CAP MEETING – 10 NOVEMBER 2021
ITEM 9.2

DEVELOPMENT NO.:	21019844
APPLICANT:	Bird in Hand Winery
ADDRESS:	150 PFEIFFER RD WOODSIDE SA 5244
NATURE OF DEVELOPMENT:	Variation to 18/828/473 to increase the floor area and the height of the cellar door, restaurant & function facility and internal alteration
ZONING INFORMATION:	Zones: <ul style="list-style-type: none"> • Productive Rural Landscape Overlays: <ul style="list-style-type: none"> • Environment and Food Production Area • Hazards (Bushfire - Medium Risk) • Heritage Adjacency • Hazards (Flooding - Evidence Required) • Limited Land Division • Mount Lofty Ranges Water Supply Catchment (Area 2) • Native Vegetation • Prescribed Water Resources Area • Water Resources
LODGEMENT DATE:	29 Jul 2021
RELEVANT AUTHORITY:	Assessment Panel at Adelaide Hills Council
PLANNING & DESIGN CODE VERSION:	2021.10
CATEGORY OF DEVELOPMENT:	Code Assessed - Performance Assessed
NOTIFICATION:	Yes
RECOMMENDING OFFICER:	Doug Samardzija Statutory Planner

- Increase the height of the building from 15.24m to 18m, an increase in height by 2.76m
- Increase the floor area by 150m², which includes a combined increase in the ground floor and first floor areas

drawing ATRIUM/MEZZANINE PLAN

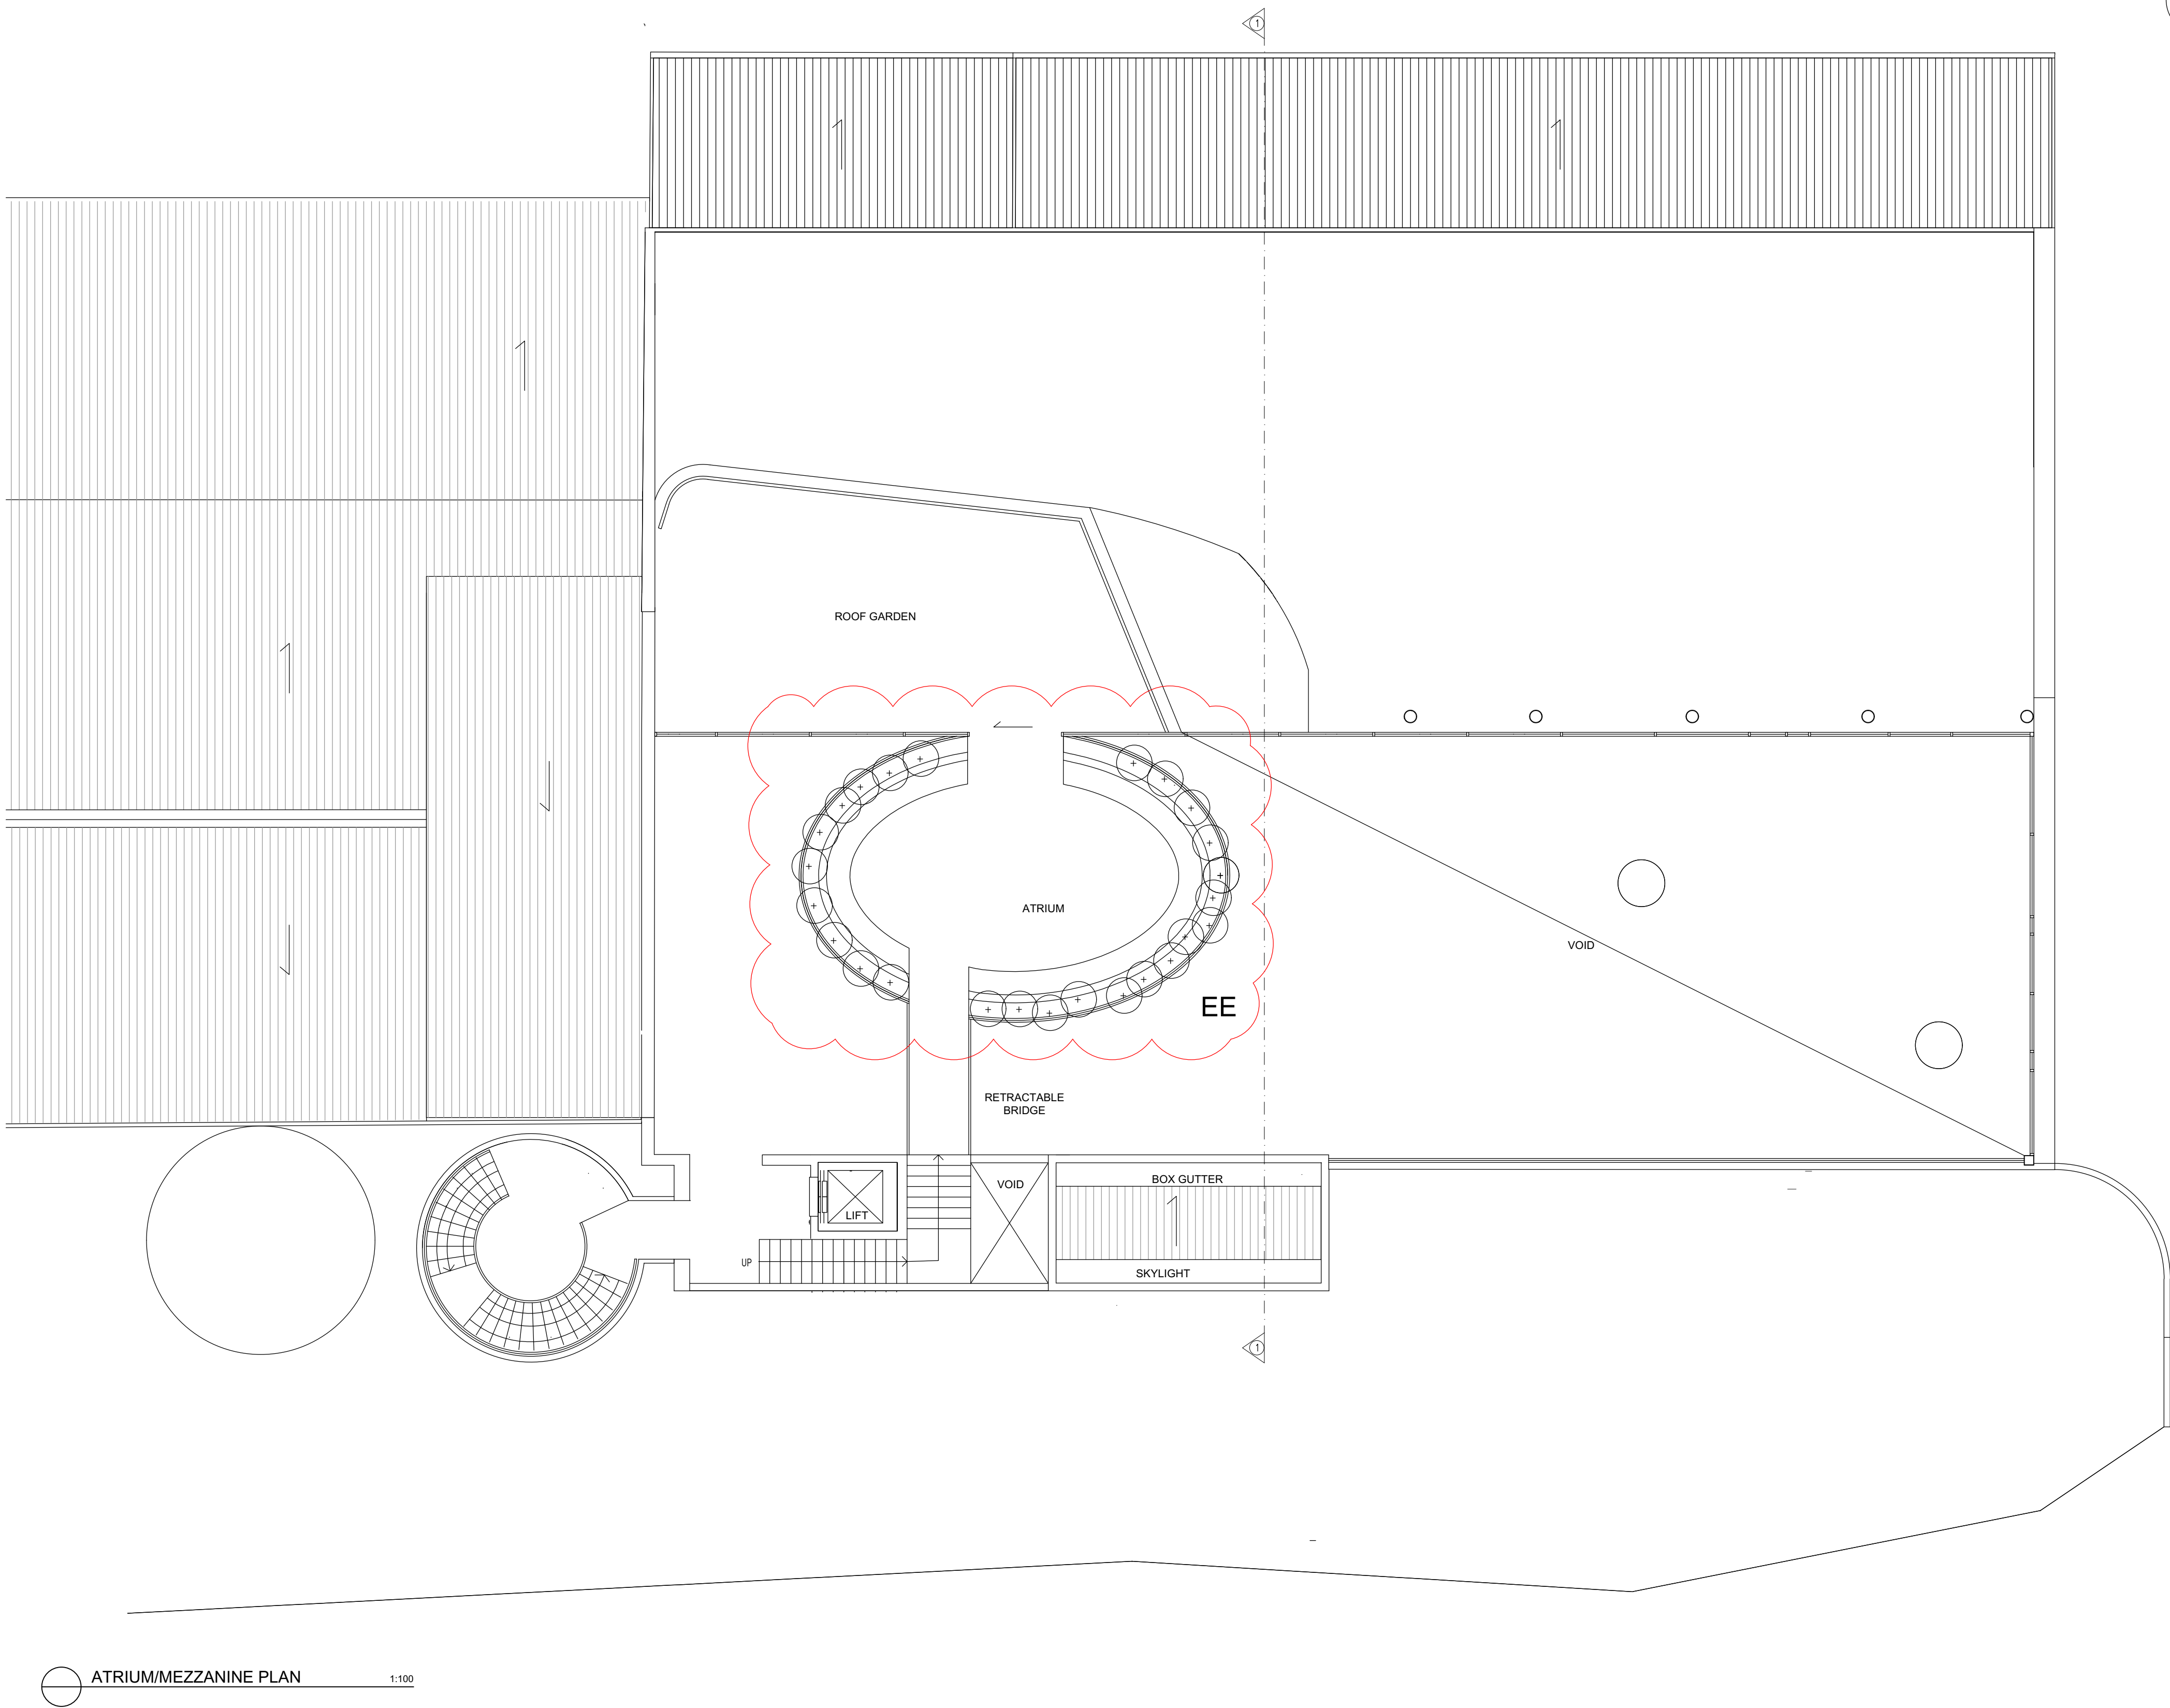
- (t) length of the floor level increased in length in an easterly direction by 3145 mm;
(u) location of the everyday access stair position changed;
(v) fire stair added to southern wall;
(w) overall roof height increased to RL 406.835;
(x) southern wall is to be rendered to match the existing wall;
(y) stair case up to mezzanine floor relocated to the on southern wall with curving roof above;

- (z) stair case added into existing silo;
